Permit No: PRRES20204198
Plan Name: 125 NW MACKENZIE DR.
Project Address: 125 NW MACKENZIE DR, LEES SUMMIT, MO 64081
Parcel Number: 203648
Location: WINTERSET VALLEY 12TH PLAT LOTS 1435 THRU 1471 & TRACTS A12 THRU D12 --- LOT 1464

STRUCTURAL REVIEW
HD ENGINEERING & DESIGN
HD: 40206 DATE: 11/5/2020

STRUCTURAL REVIEW
HD#: 40226

MAIN FLOOR PLAN
SCALE: 1/4" = 1'-0"

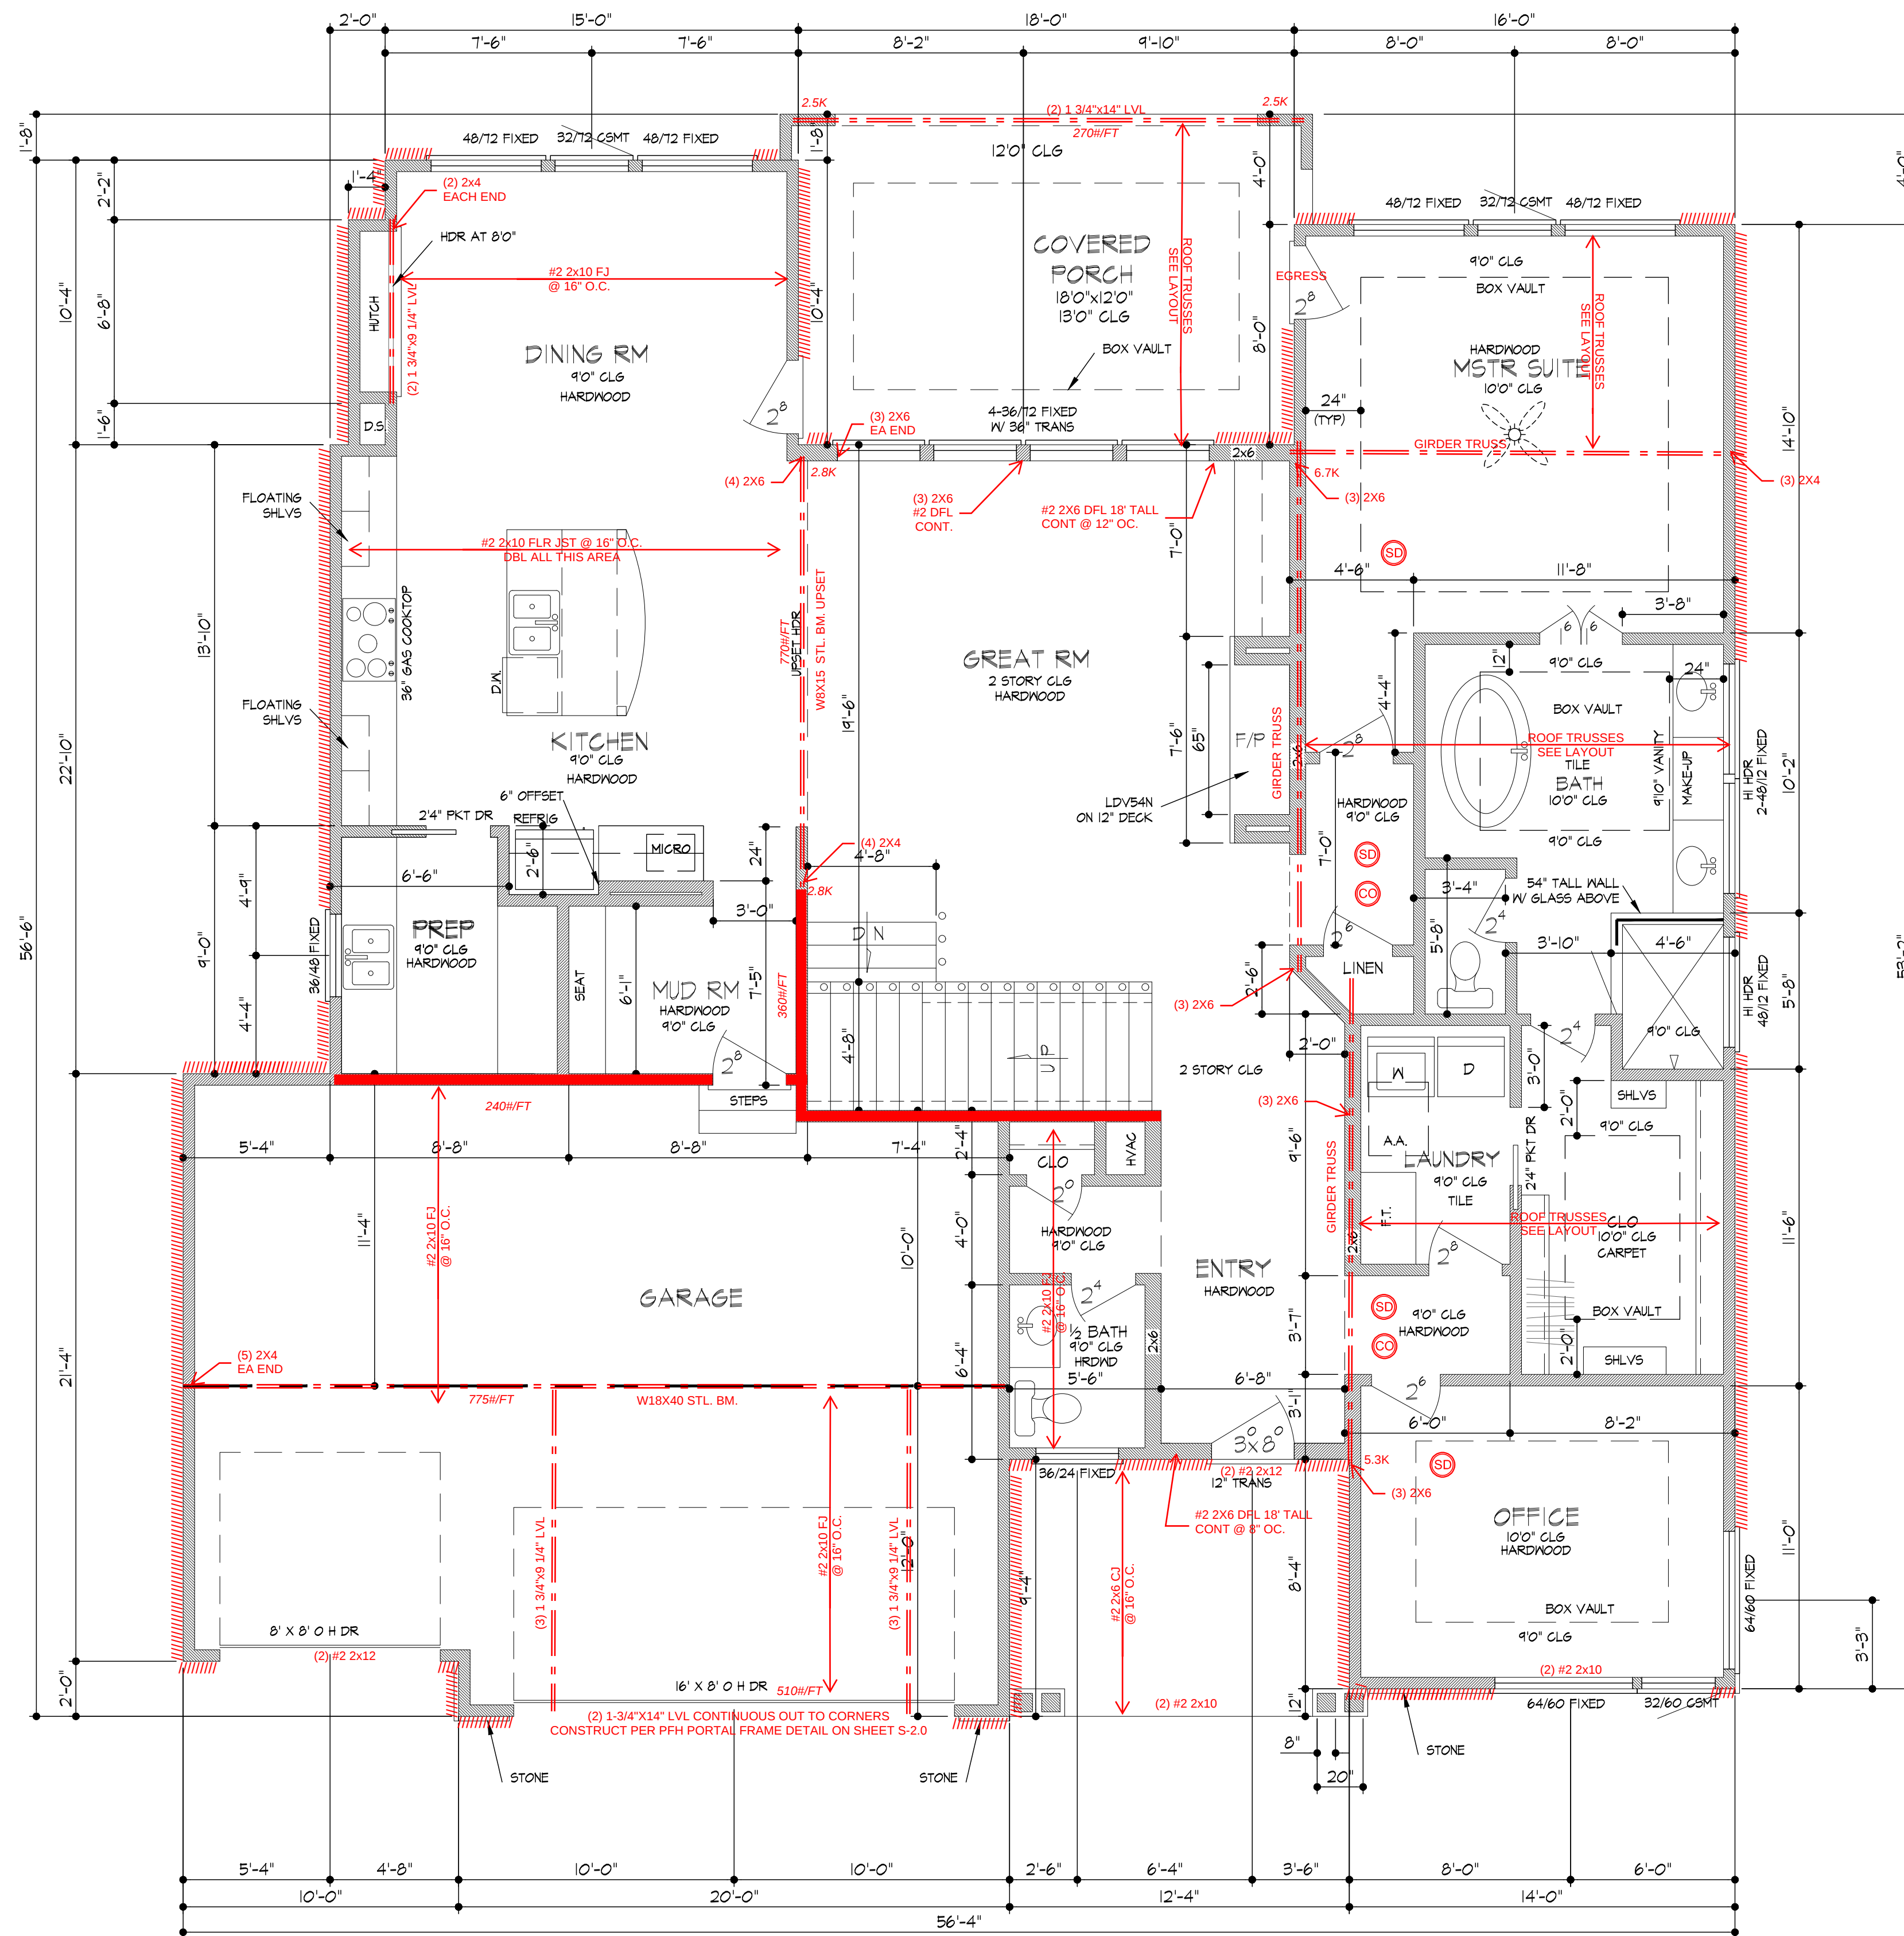
1. Provide square footage of living area, garage area, unfinished basement area, etc (IRC Section R304)

PLEASE LABEL THE FOLLOWING SQUARE FOOTAGES:

1. UNFINISHED BASEMENT
2. GARAGE
3. COVERED DECK

SEE REVISED CLOUDED PLAN

670 SF GARAGE
115 SF FRONT PORCH
216 SF COVERED PORCH
1817 SF UNFINISHED BASEMENT

ROOF PLAN
SCALE: 1/4" = 1'-0"

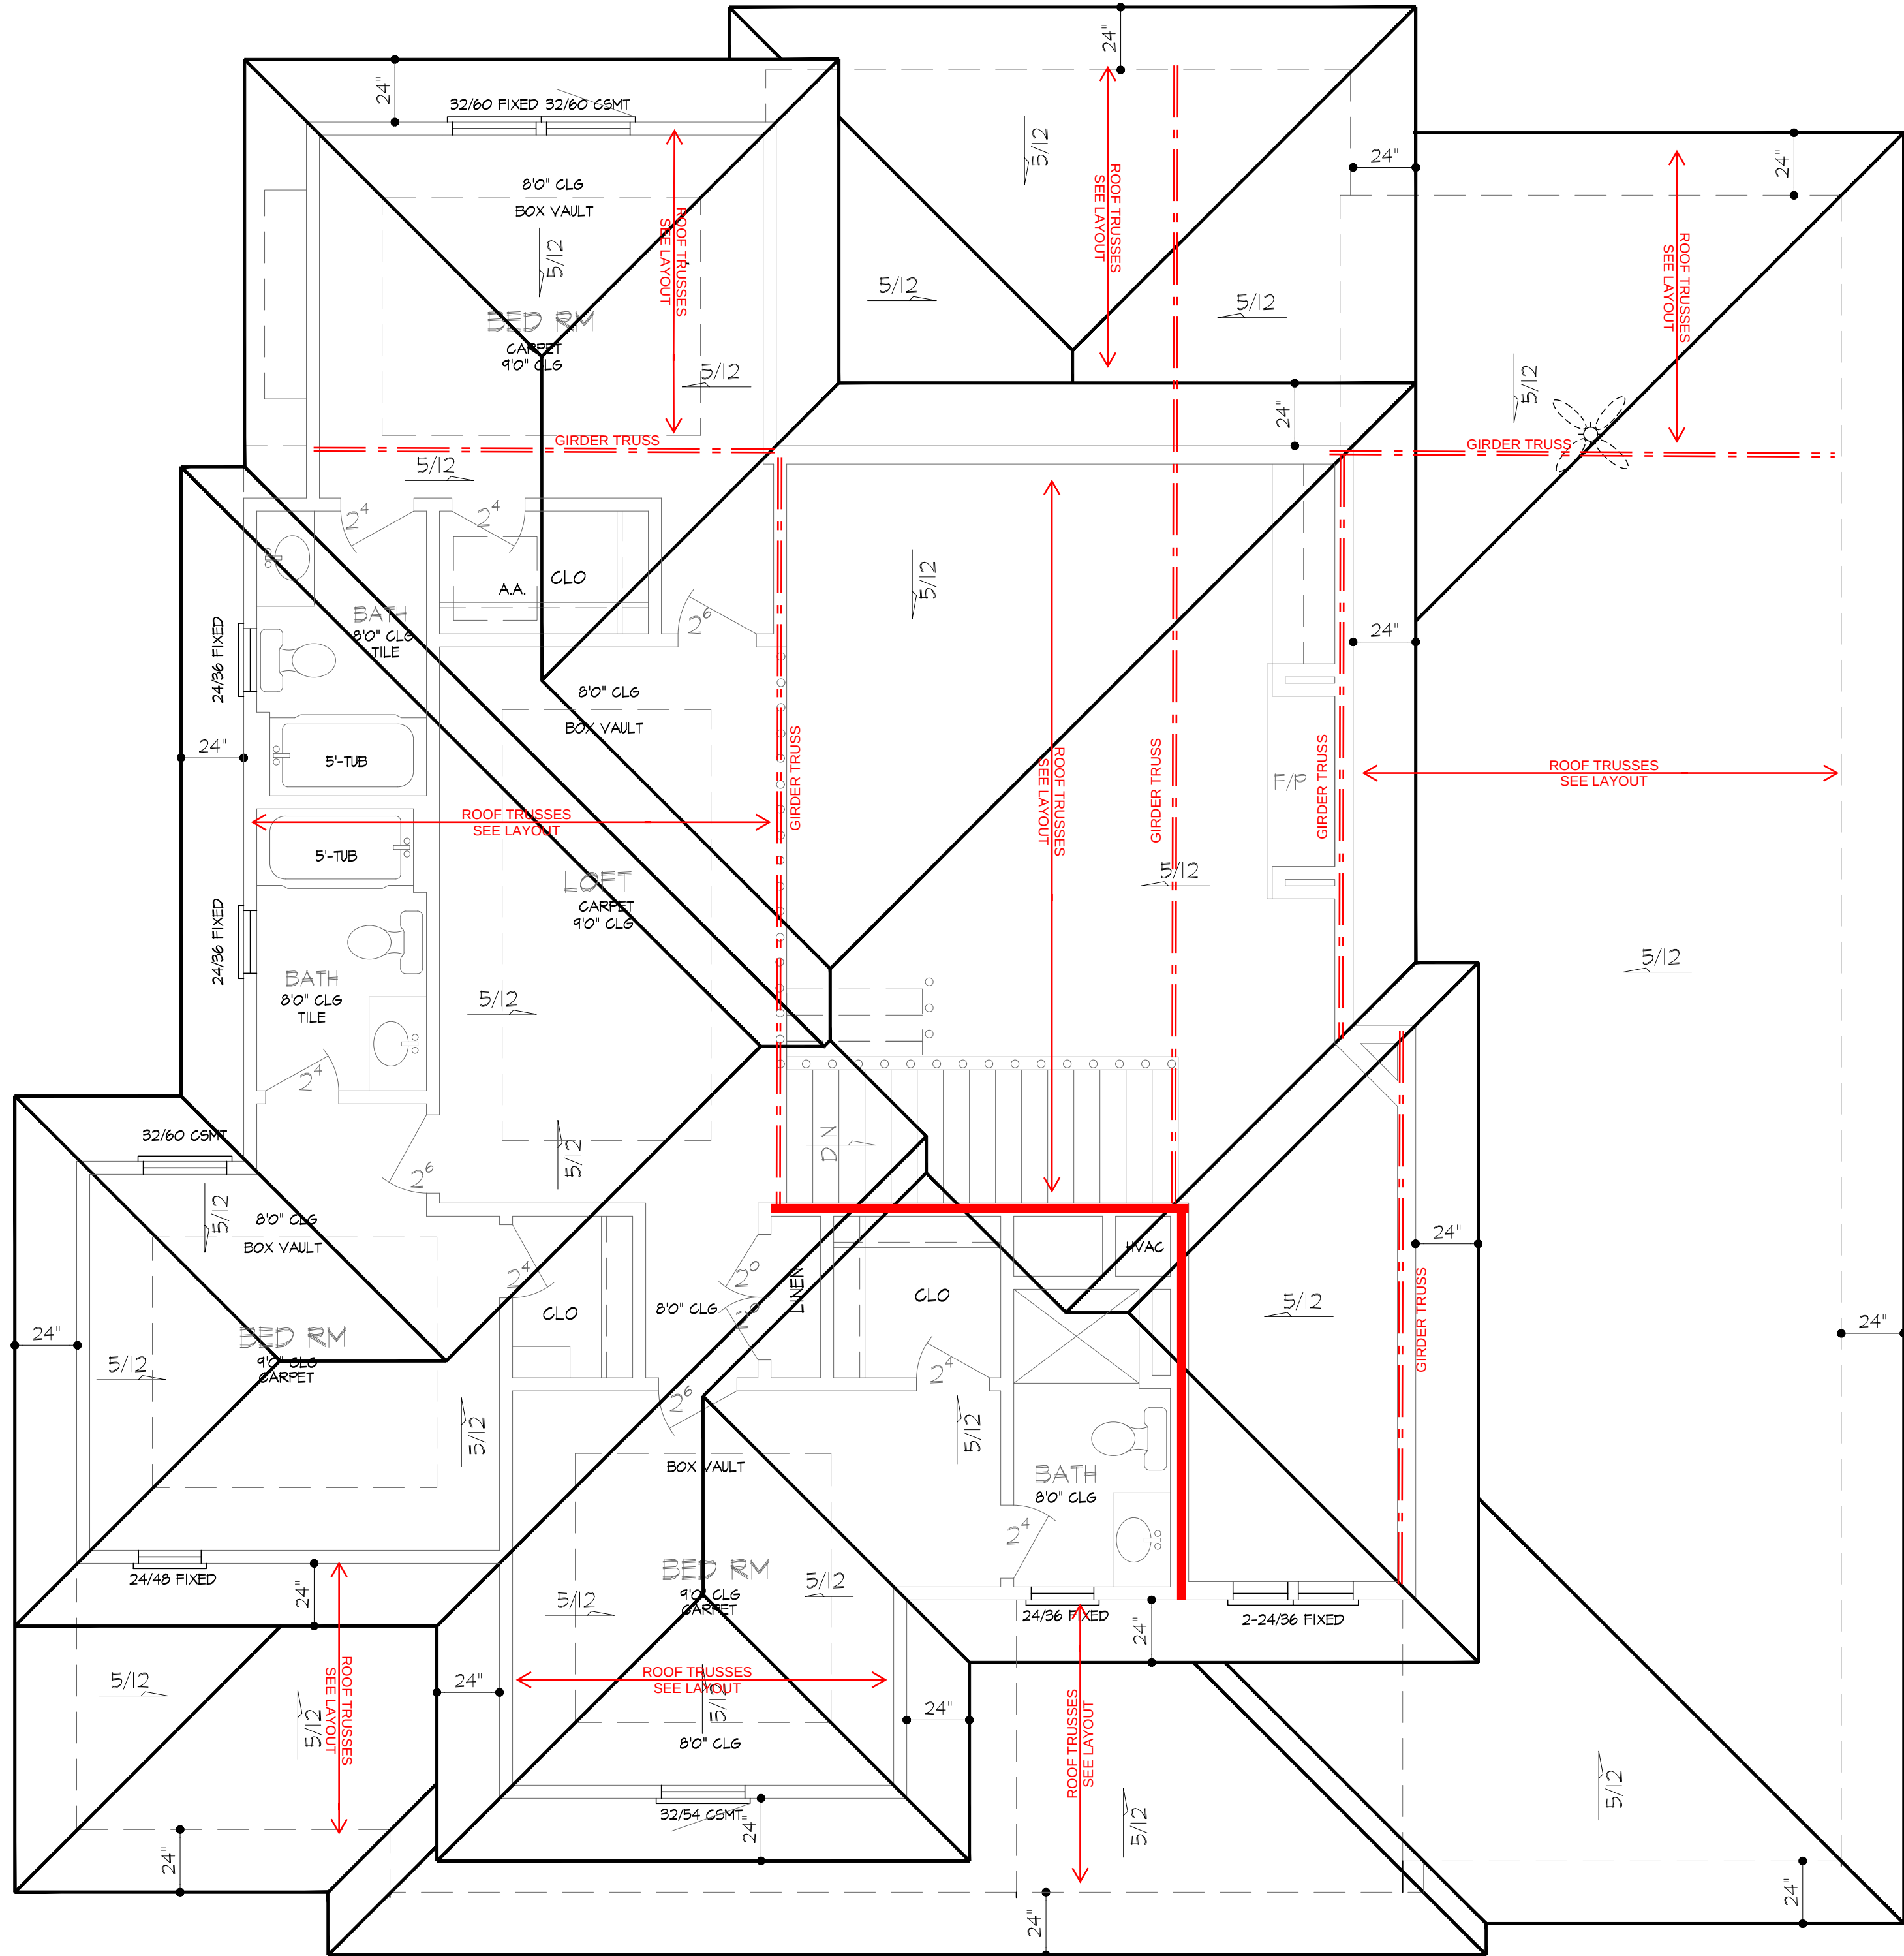
2. Identify type of roof/truss package (if used) complete with layout, component design, fastening details, blocking and sheathing requirements. (IRC Section 802.10)

DEFERRED I HAVE RECEIVED THE TRUSS LAYOUT BUT STILL NEED THE TRUSS PACKAGE WITH THE SPEC SHEETS THAT ARE STAMED BY A DESIGN PROFESSIONAL.

DEFERRED, PROVIDED BY BUILDER
